Re: Trans Mountain Pipeline ULC ("**Trans Mountain**")
 Trans Mountain Expansion Project ("**TMEP**" or "**Project**")
 File OF-Fac-Oil-T260-2013-03 60
Combined Section 211 and Section 208 Application for Burnaby Lands

1. Trans Mountain applies to the Commission (i) under Section 211 of the *Canadian Energy Regulator Act* ("**CER Act**") for approval of a deviation to, and (ii) under Section 208 of the CER Act for approval of corrections to certain omission, misstatements or errors ("**Errata**") in, the approved Plan, Profile and Book of Reference ("**PPBoR**") for Segment 7 of the Project, on the following lands:

Requirements in Respect of the Deviation Lands

Appendix C
Mapping

**TRANS MOUNTAIN EXPANSION PROJECT
PLAN AND PROFILE OF TMEP EASEMENT
KP 1175+941 TO KP 1177+477
092G02L & 092G07D**

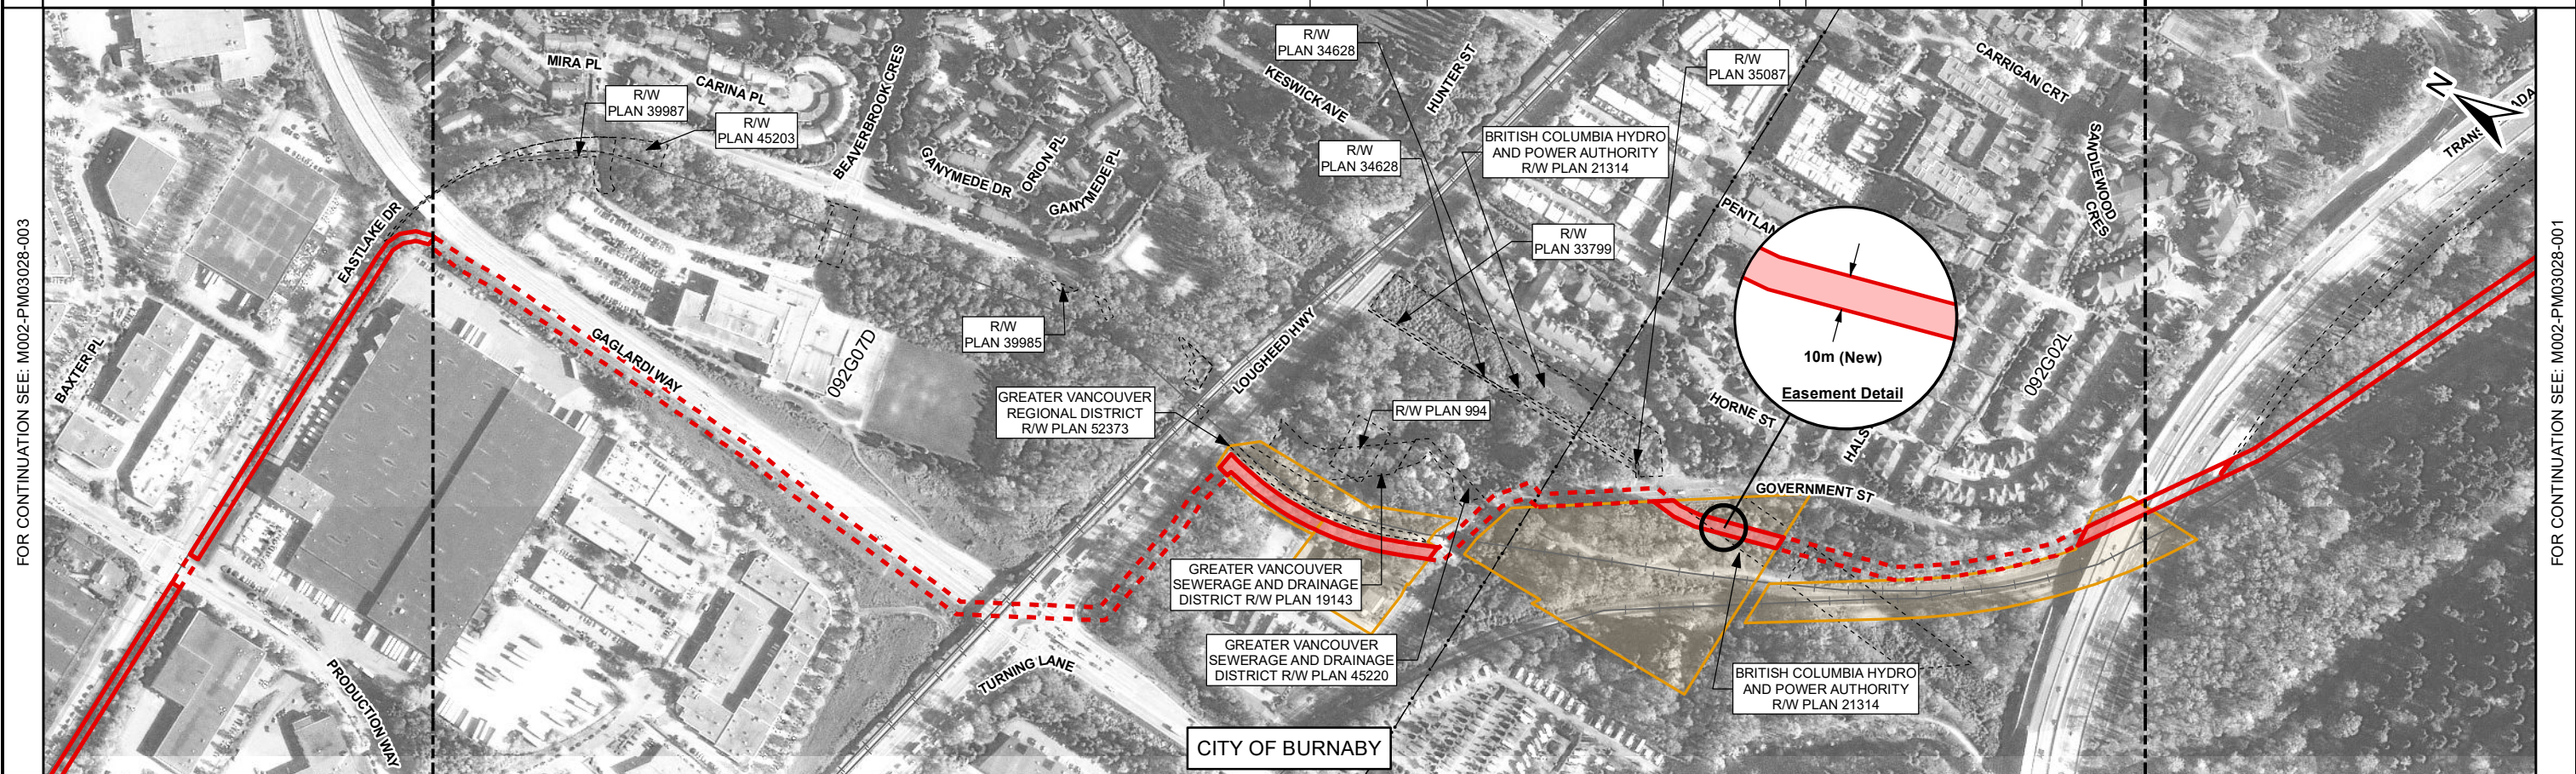
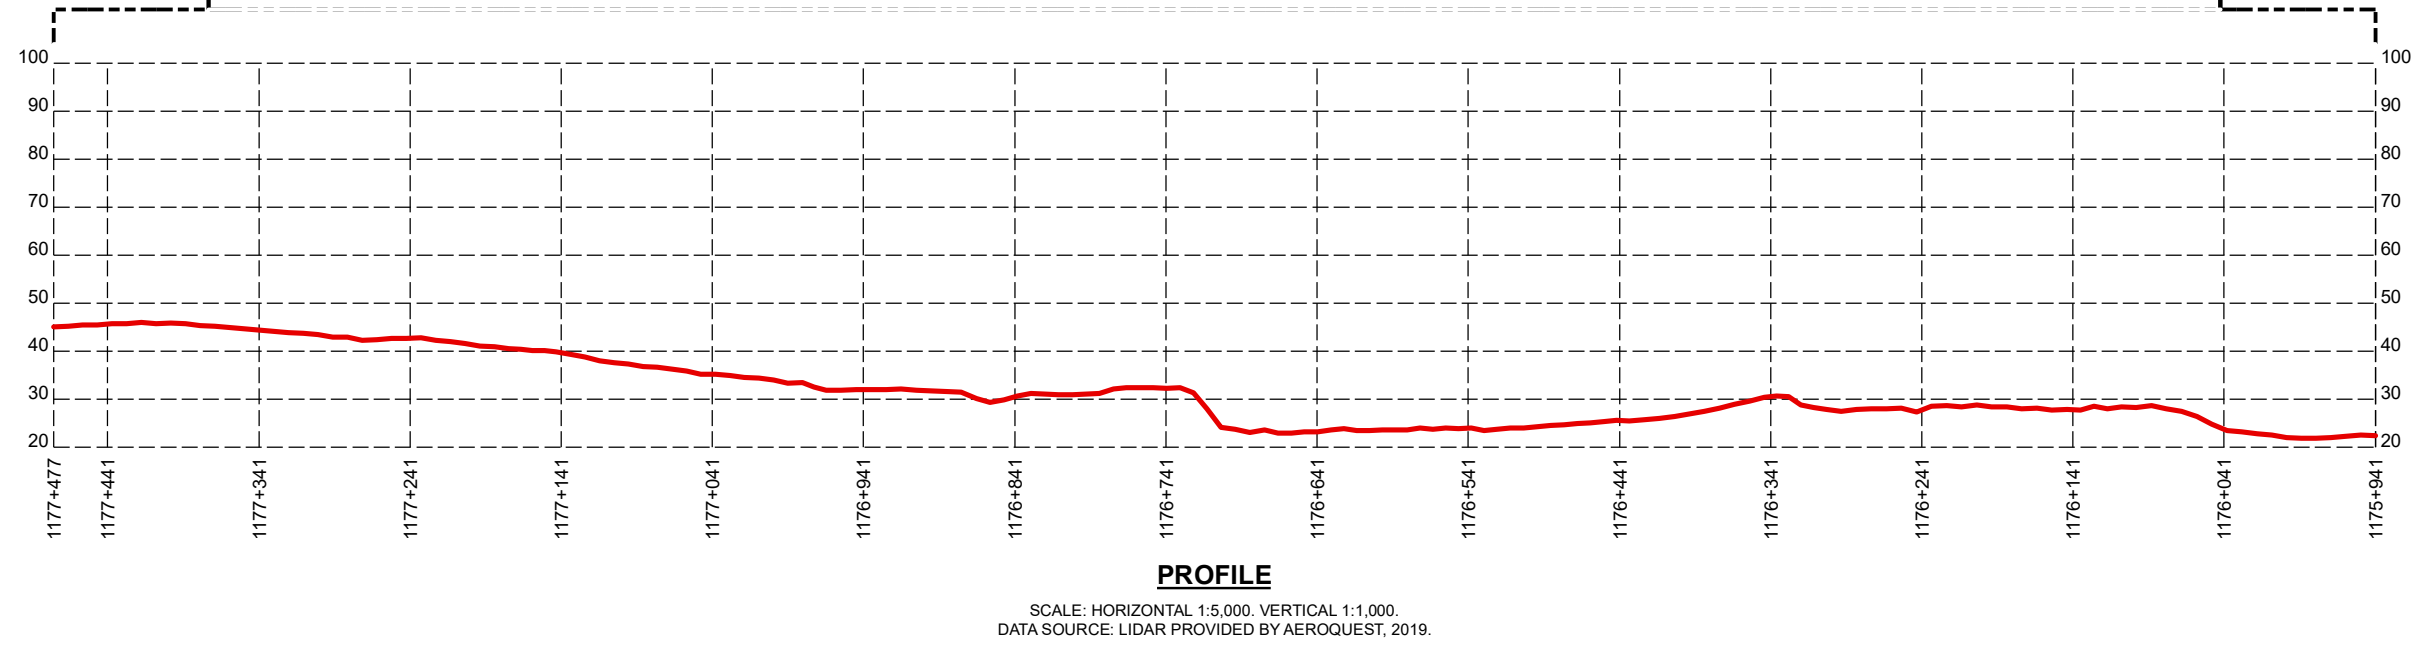
| CER Manual, Guide D Requirements | | Trans Mountain Response |
|---|--|---|
| D.1(4) | Provide the starting and ending points of the deviation (kilometre post to kilometre post). | For Tracts PC 7722 and PC 7723, KP 1176.34 to KP 1176.70. For Tract PC 7755, KP 1178.61 to KP 1178.79. |

| Errata # | Tract | Landowner | Legal | Segment | Original PPBoR Filing ID | CER Order | Update |
|----------|---------------|--|--------|---------|--|-------------------------|---|
| 1. | PC 8101.03 | Brunette River Conservation Area (City of Burnaby) | Park 9 | 7.7 | M002-PM03028-002 R3 (C08917, PDF 7-8) | AO-001-OPL- 004-2020 | Easement for route across the lands is being replaced with a non-easement agreement on the basis that the lands are not titled lands. Trans Mountain notified the City of Burnaby of this correction in advance of filing. |

**DETAILED MAP TRACT NUMBER:
PC7755**

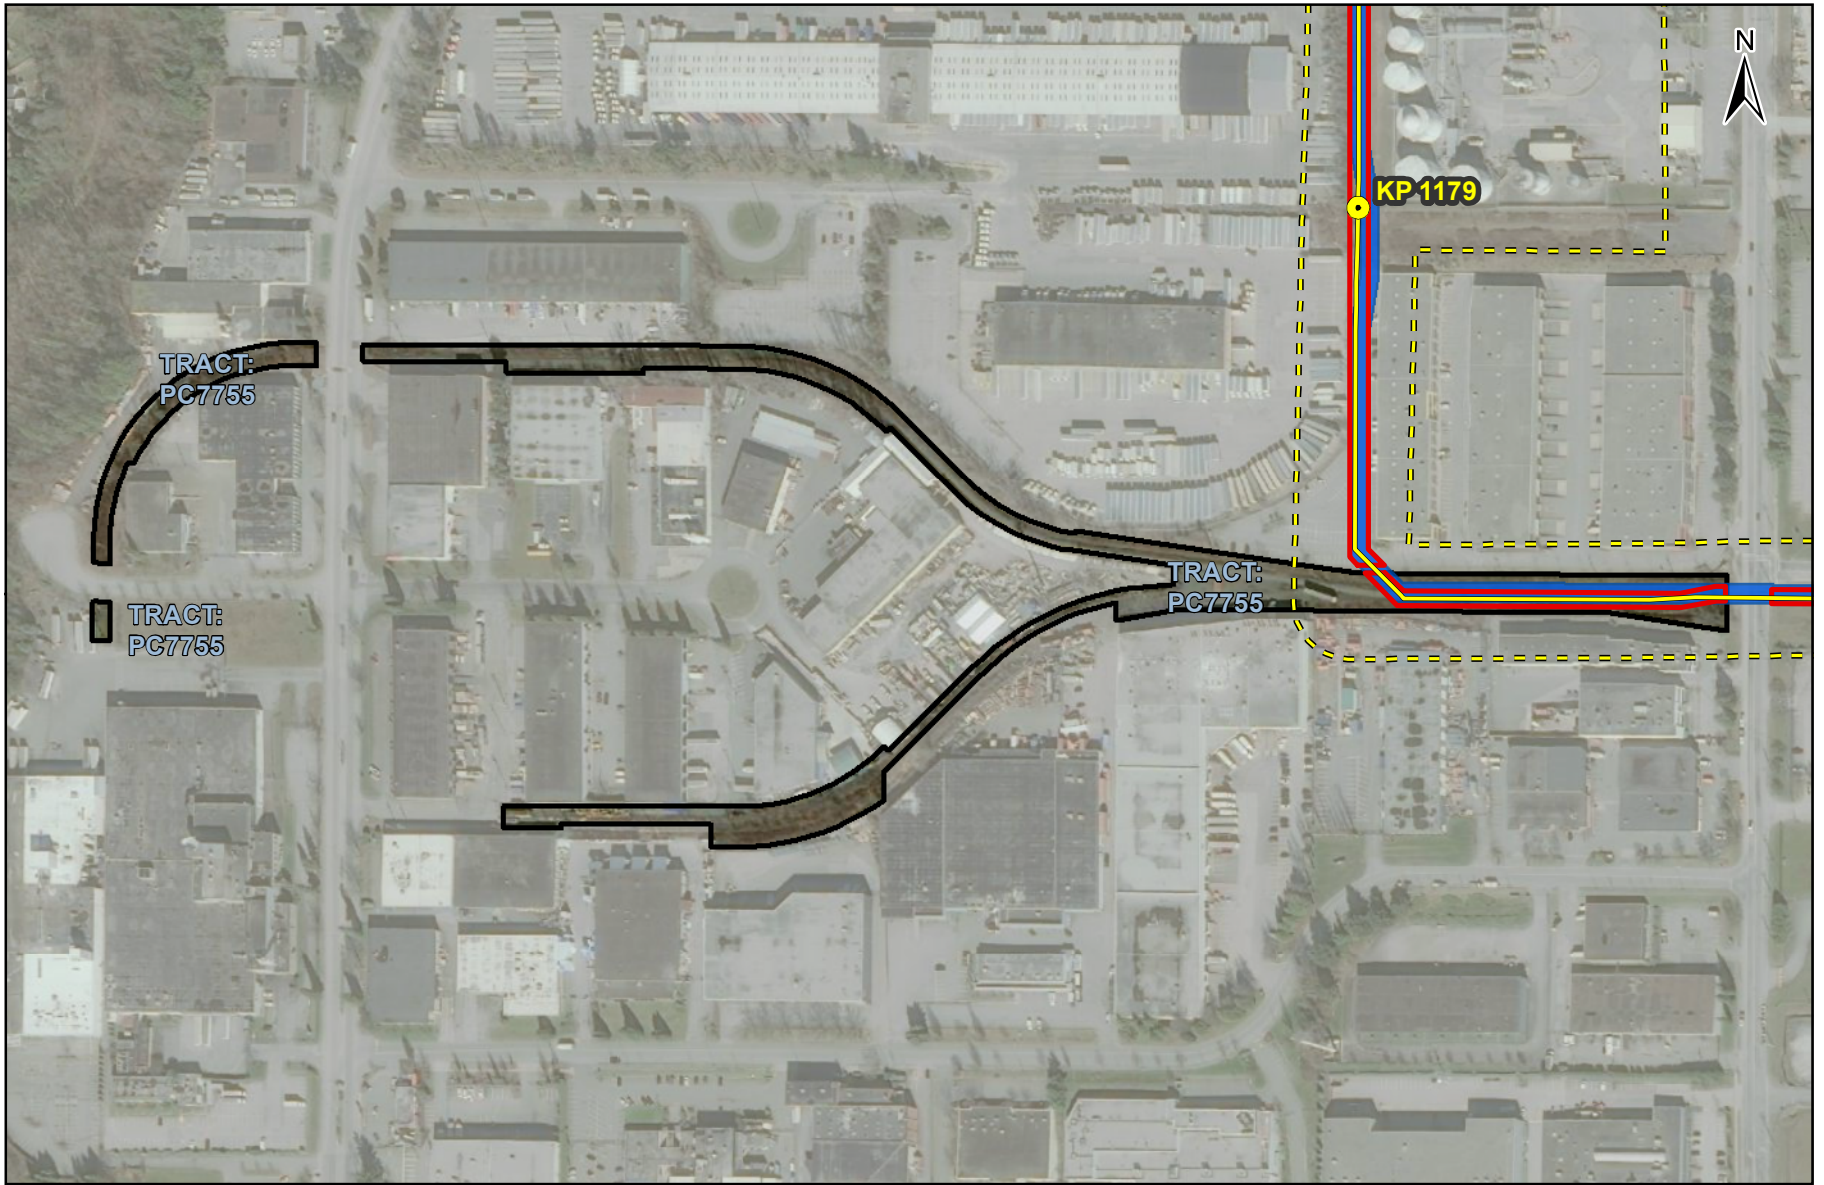
| CER Manual, Guide D Requirements | | Trans Mountain Response |
|---|--|---|
| D.1(5) | Include a map at an appropriate scale that indicates the location of the deviation in relation to both the approved detailed route and the certificated route of the pipeline. Include surrounding natural and man-made features on the map. | Attached as Appendix C-2 . |
